Th14a

Prepared March 22, 2012 (for April 12, 2012 Hearing)

From: Madeline Cavalieri, District Manager
Daniel Robinson, Coastal Planner

Subject: **Appeal A-3-SLO-11-064 (Lewis Residence).** Appeal by Maria Jaqua, John Carsel, and Carol Baptiste, and John and Sue Black of San Luis Obispo County decision granting a coastal permit with conditions to Dr. Marshall Lewis for demolition of an existing 2,810 square-foot, one-story single-family dwelling (SFD) and construction of a new 4,555 square-foot, two-story SFD with a 2,377 square-foot underground garage, and relocation of an historic water tank on site, at 709 Lucerne Road in the Cayucos area of San Luis Obispo County. Appeal Filed: September 19, 2011. 49th Day: Waived.

EXHIBIT A- VIEW FROM SOUTHBOUND LANE OF HWY 1

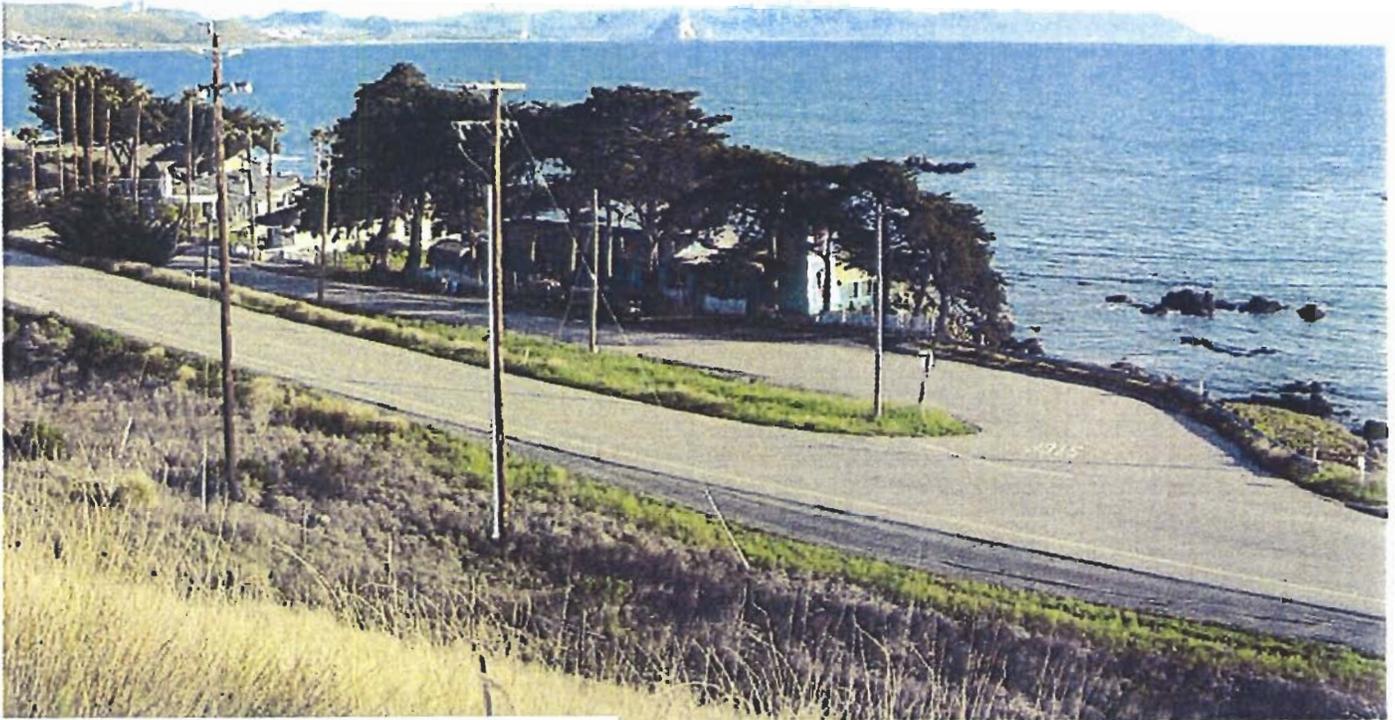
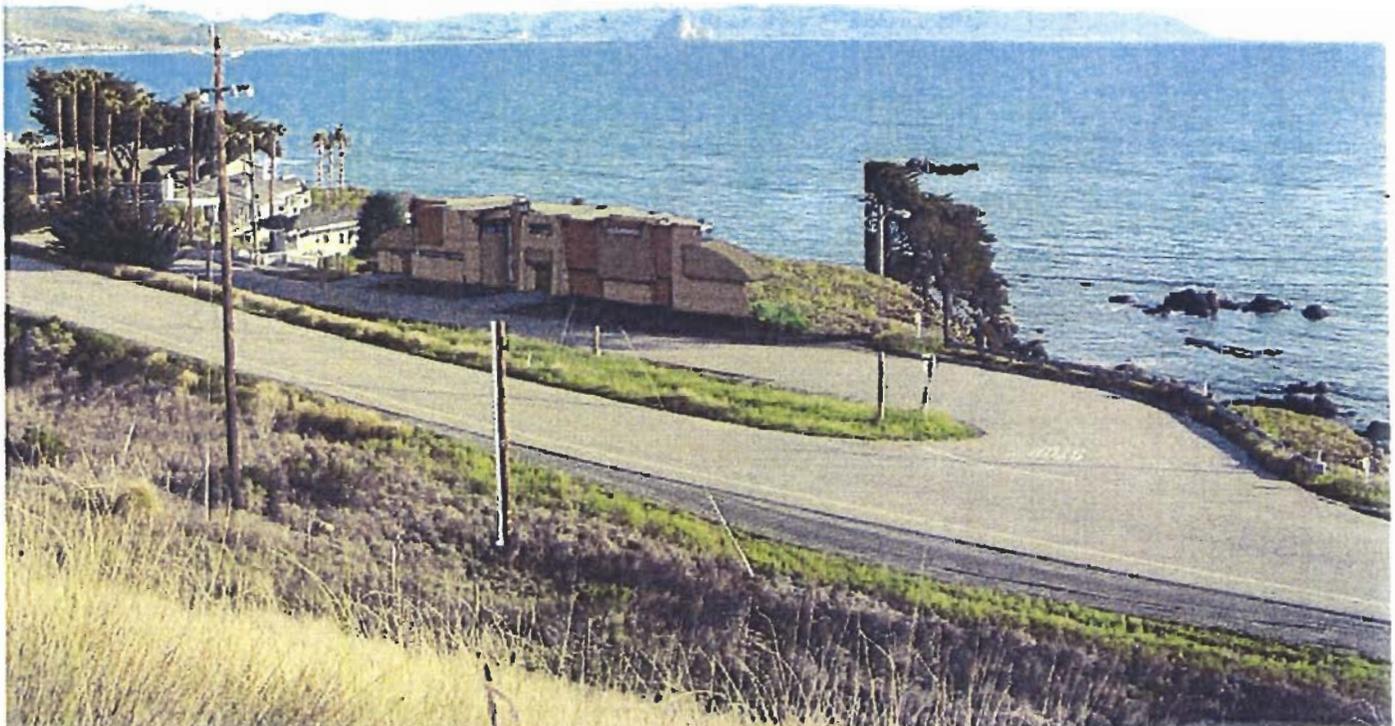
The proposed project will substantially impact the view for both cyclists and motorists. The change from the existing to the proposed structure couldn't be more dramatic (See Exhibit B). Instead of a small picturesque structure under a canopy of Monterey Cypress trees, that allow filtered views of the ocean and horizon beyond, there will be an extremely long, uninterrupted two-story high wall with no view corridors and no mature trees to soften or obscure the sight of it. There is nothing on Lucerne like this 127 foot long, two-story fortress built right against the street frontage. The typical large home

In terms of the view of the site from Highway 1, this view is limited due to the Highway being at a higher elevation than the site. Northbound Highway travelers cannot see the site, and travelers passing along southbound Highway 1 can only catch a glimpse of the project site for a short duration given the grade separation. Even then, what are visible are the tops of a fairly solid mass of cypress trees. It is not until travelers exit Highway 1 and take the frontage roads that a full view of the site is possible. Thus, the main public view affected by the proposed project is from the frontage roads, and not from Highway

Historical Bluff Erosion
And Undermining
Coastal Record Project

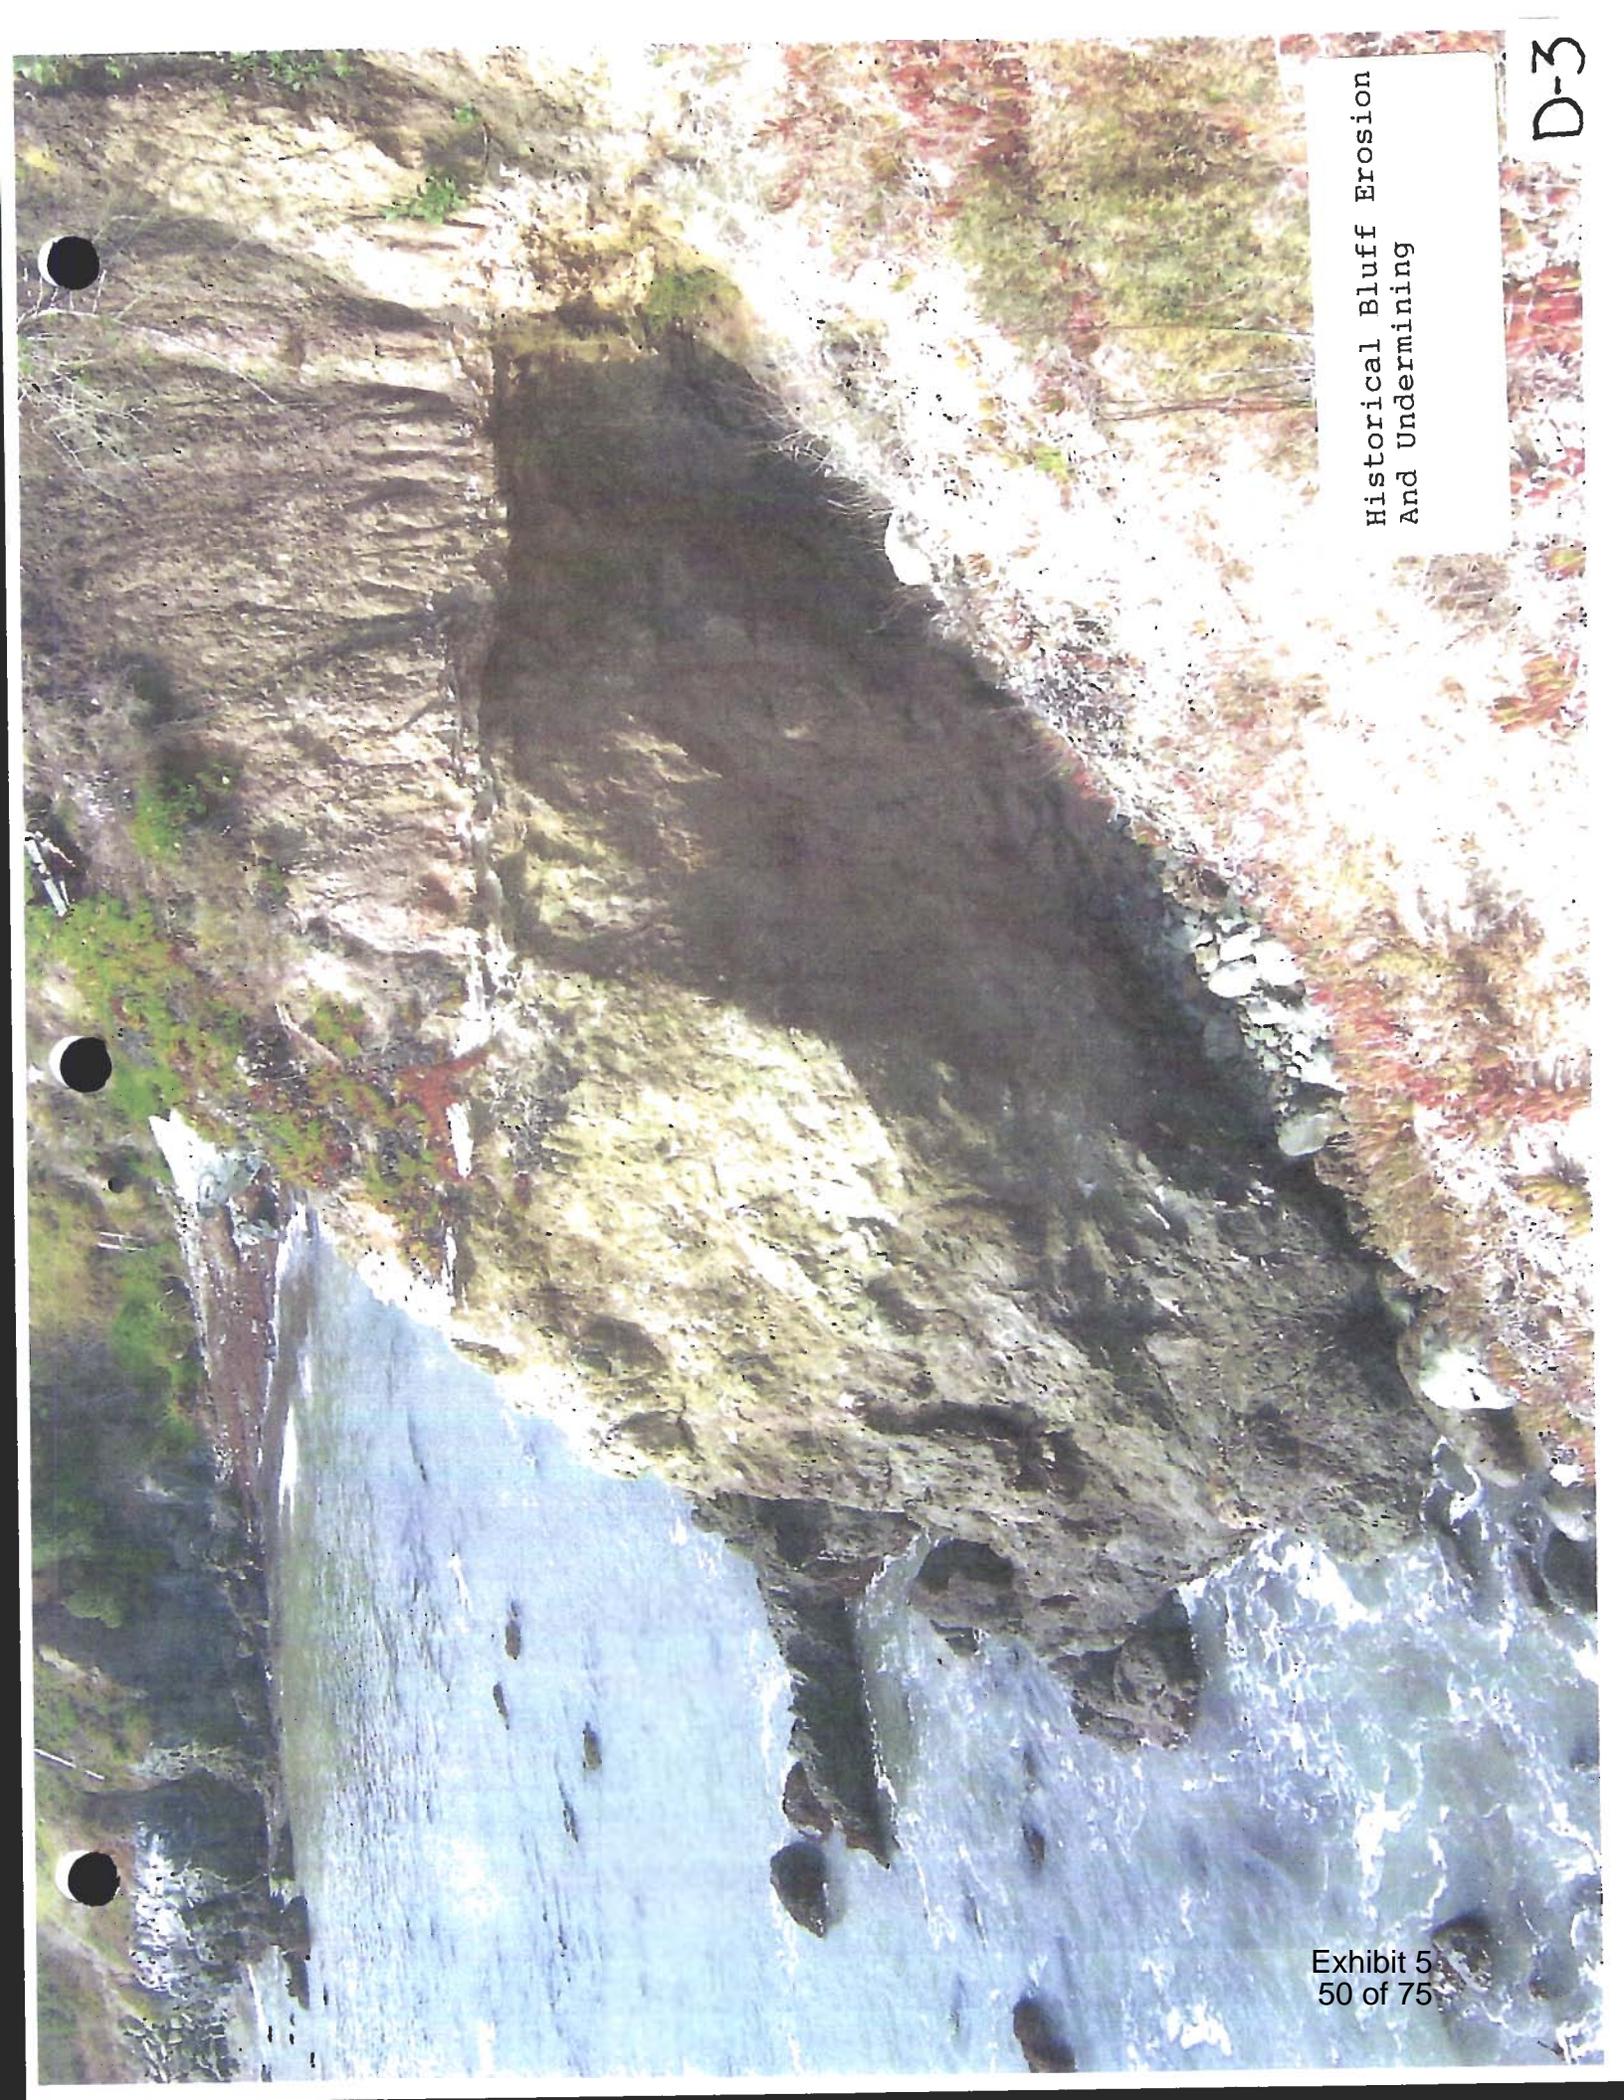
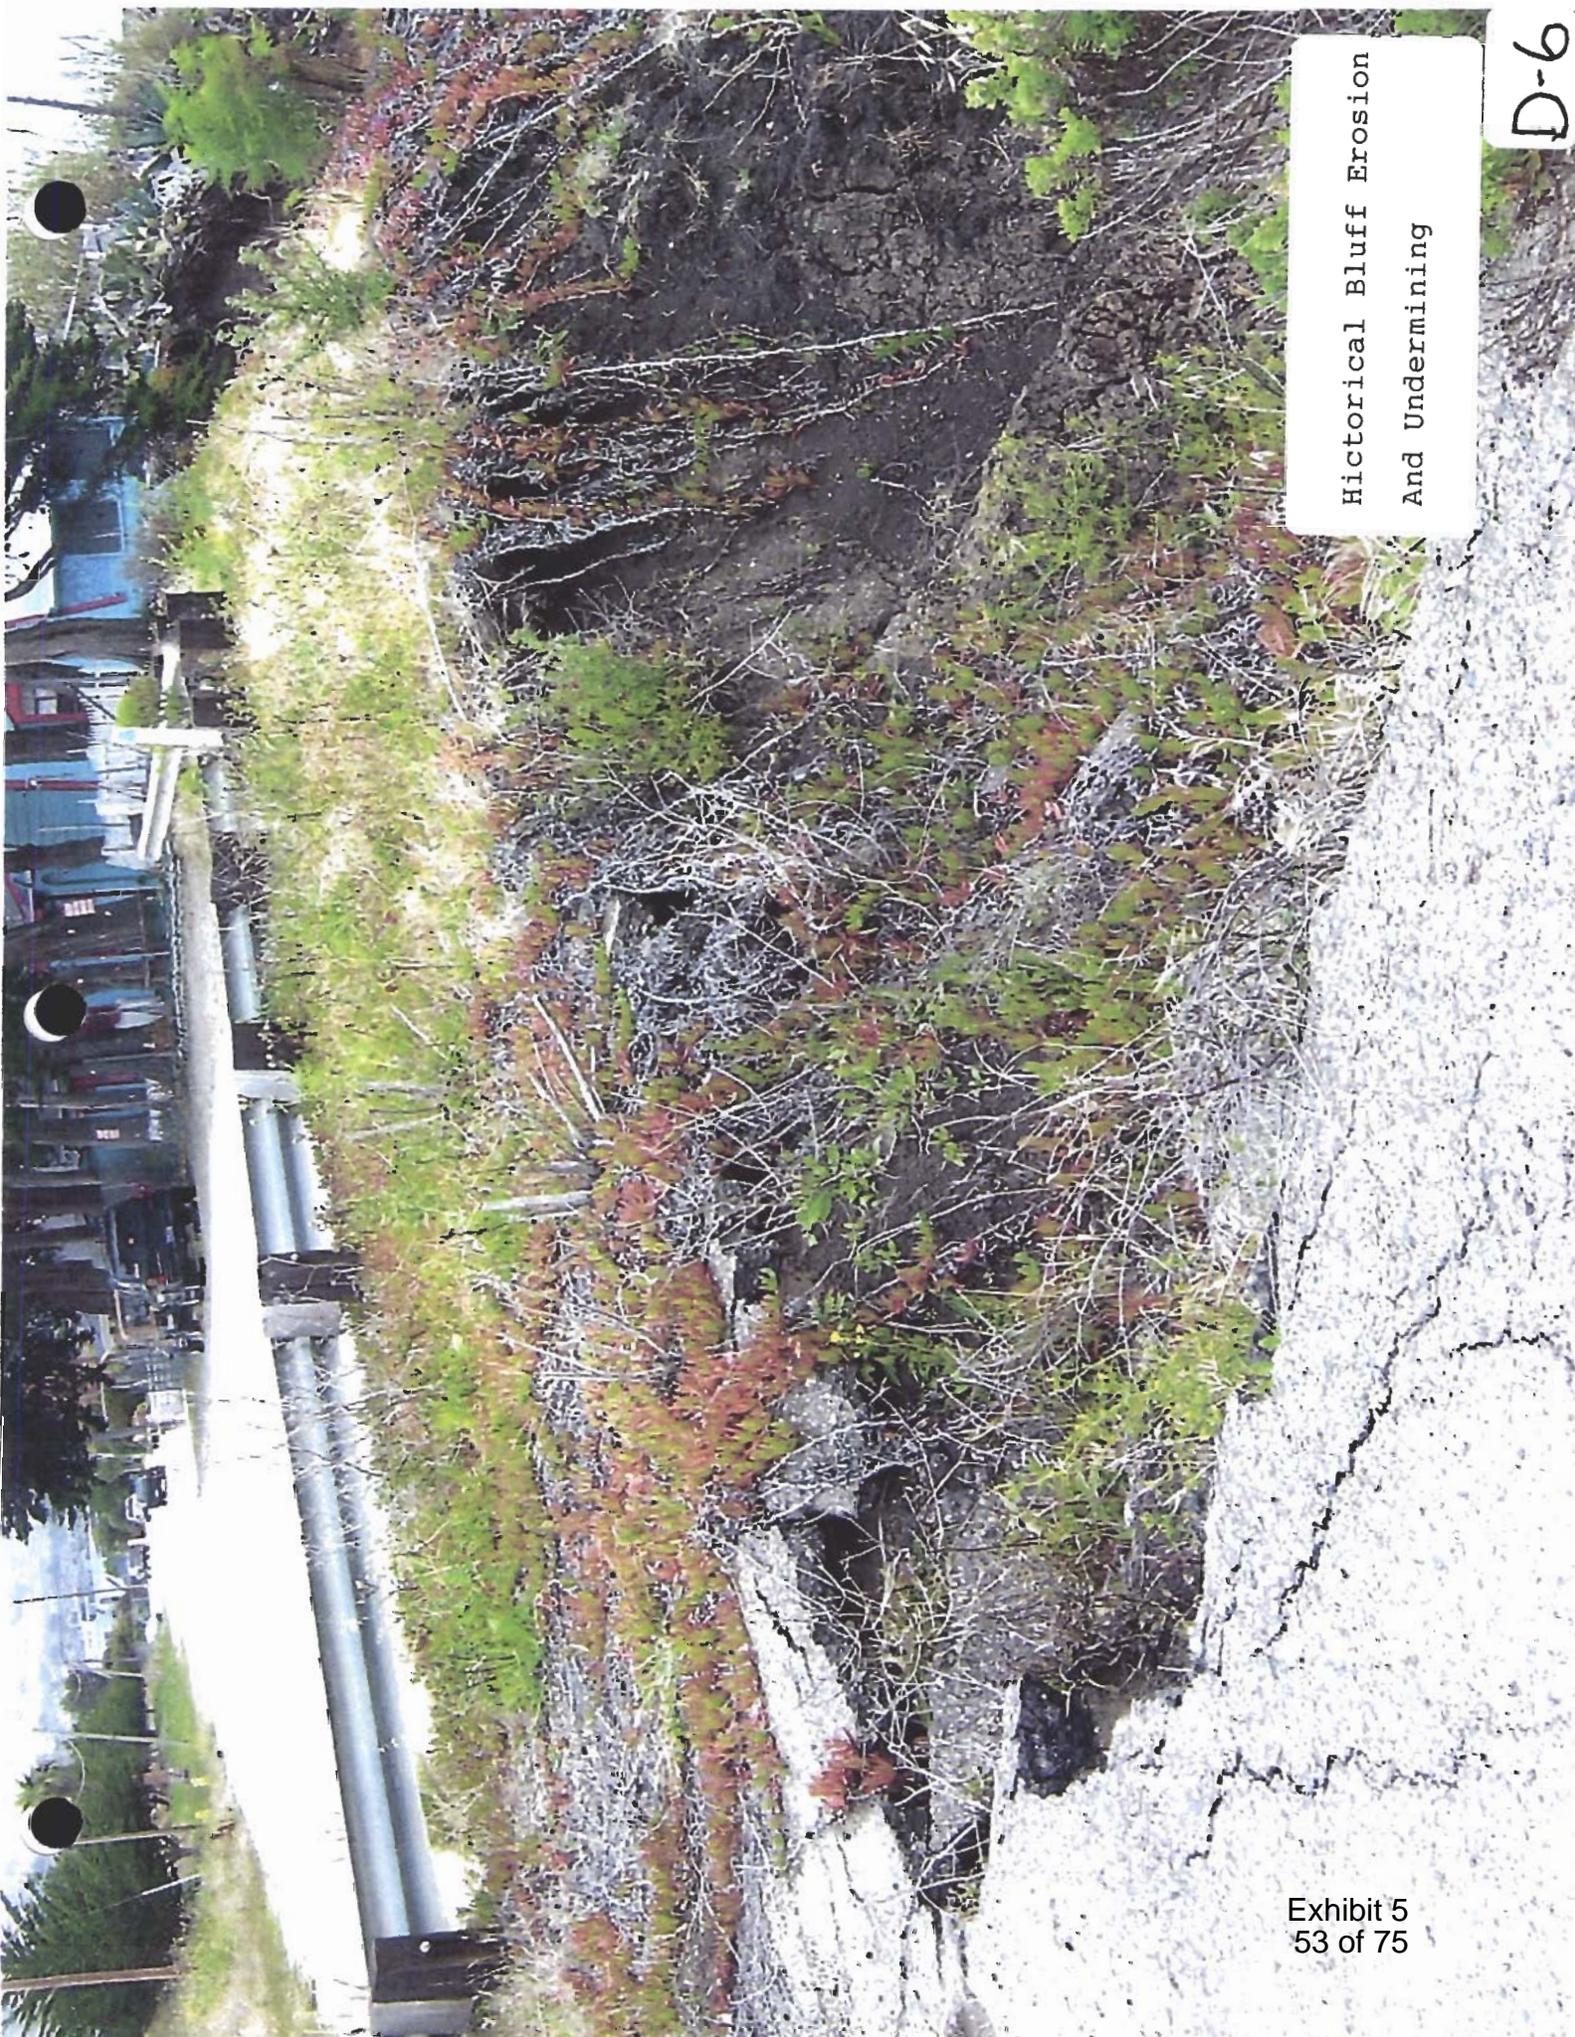
We believe that the proposed basement excavation will be in the area of extreme and **ongoing bluff erosion and undermining**, which we feel **were not adequately addressed** in the applicants geological report. The applicant's own geologist, GeoSolutions, in it's January 26, 2011 review of the project (**See Exhibit D-1 - Neglect to Supply Requested Geological Information**) even states that "The slope stability analysis indicates that the addition of a basement **"does not appear"** to affect the instability of the bluff" This comment **seems indecisive, and non-concrete.** This information is critical in determining the 100 year erosion factor that is applied to coastal bluff projects to establish coastal bluff setbacks, as well as the relative stability of the bluff itself. **This parcel has a particular history of accelerated erosion** due to instability of the bluffs and wave action during winter storms. (**See Exhibits D-2 through D-8 - Historical Bluff Failures and Undermining**)

residential development, and that the new residential development is set back from the coastal blufftop edge an appropriate distance to adequately minimize hazards to life and property under the LCP. Specifically, the new residential development is set back 40 feet on the western side and 30 feet on the eastern side from the blufftop edge (see approved project plans in Exhibit 7, pages 68-78).⁴ These setback distances meet LCP requirements.^{5,6}

The Appellants also specifically contend that the project's underground garage would lead to further bluff instability and erosion, and that a nearby spring was not appropriately addressed in terms of geologic impacts. The Applicant's geotechnical consultants prepared a report that addresses these issues, concluding that the basement does not negatively affect bluff stability and that potential impacts associated with the spring have been appropriately addressed.⁷ With respect to the latter, although groundwater was not found within the area of the garage (proposed to a depth of 11 feet below land surface), the presence of groundwater was modeled through a formal slope stability analysis at between 2 and 4 feet above the Franciscan bedrock (encountered approximately 22 to 25.5 feet below the ground surface) as a conservative element incorporated into the stability modeling. This analysis was part of the information used to develop the above-described setbacks, and it appears to have adequately addressed the spring/groundwater issue (see Exhibit 4 and Exhibit 7 pages 120-131). In addition, the Commission's senior geologist, Dr. Mark Johnson,⁸ has reviewed the relevant reports and concurred that it is likely that the majority of groundwater flow in this situation, as is commonly the case in this region, is through the marine terrace deposits lying on top of the bedrock layer. Plans show that the garage is not extending into the bedrock, leaving approximately 13 feet of marine terrace deposits intact, and thus that it is unlikely to affect groundwater flow, bluff stability and erosion at this location.⁹ In addition, the County attached conditions to appropriately address stability, excavation, and groundwater issues, including requirements for: a drainage plan (to be prepared by a registered civil engineer); a sedimentation and erosion plan; an on-site engineering geologist to monitor the site during excavation; and appropriate construction materials designed to retain earth and waterproof the development, all designed to help ensure bluff integrity throughout construction and after completion.
